DISPUTE REVIEW BOARD RECOMMENDATION

Re: US 19 SR 55 W. Green Acres to Jump Court Citrus County, Fl.

FPN 405822-2-52-01

Disputes Review Board Recommendation

Figure 4: T7438 Plan Note for Artesian

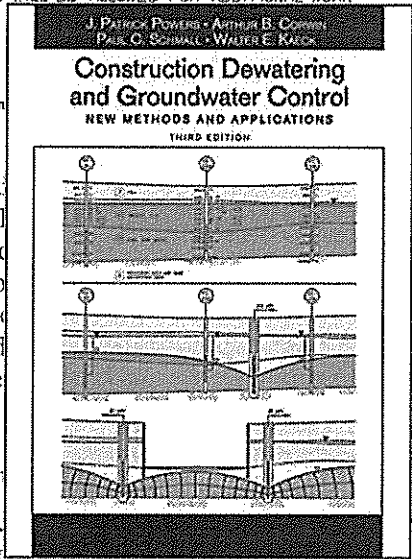
8. IT HAS BEEN THE EXPERIENCE OF FDOT, WITH PROJECTS CONSTRUCTED WITHIN THIS GENERAL GEOGRAPHICAL AREA, THAT THE POTENTIOMETRIC SURFACE ELEVATION OF THE UPPER FLORIDAN AQUIFER ALONG THE PROJECT ALIGNMENT RANGES FROM APPROXIMATELY +65 TO +70 FEET, NGVD. THEREFORE, THE CONTRACTOR SHOULD CONSIDER THE INCREASED COST OF ALL UNDERGROUND WORK ACTIVITIES WHILE PREPARING THEIR BID, WITH THE KNOWLEDGE THAT EQUIPMENT AND METHODS MAY BE REQUIRED TO HANDLE ARTESIAN FLOW CONDITIONS TO A HEAD ELEVATION OF +70 FEET, NGVD. ALL COSTS OF DEWATERING ACTIVITIES SHALL BE INCLUDED IN THE APPROPRIATE ITEMS OF WORK CONTAINED IN THE CONTRACT. NO EXTRA COMPENSATION OR TIME EXTENSION WILL BE ALLOWED FOR ADDITIONAL WORK OR EQUIPMENT DIRECTLY ASSOCIATED WITH THE DEWATERING ACTIVITIES.

FDOT and the Construction Engineering and Inspection Company (CEI) issued these notes to avoid compensating D.A.B. for additional bedding stone. Since specific dewatering rates cannot be defined in the plans, it appears that FDOT possessed superior knowledge and failed to provide this information to prospective bidders. D.A.B. and FDOT exists. FDOT has maintained that the dewatering project were clearly defined within the Contract Documents. The Contractor, D.A.B. fundamentally disagrees with this expense due to Extra Work and Delay attributed to conditions encountered during construction operations on the project.
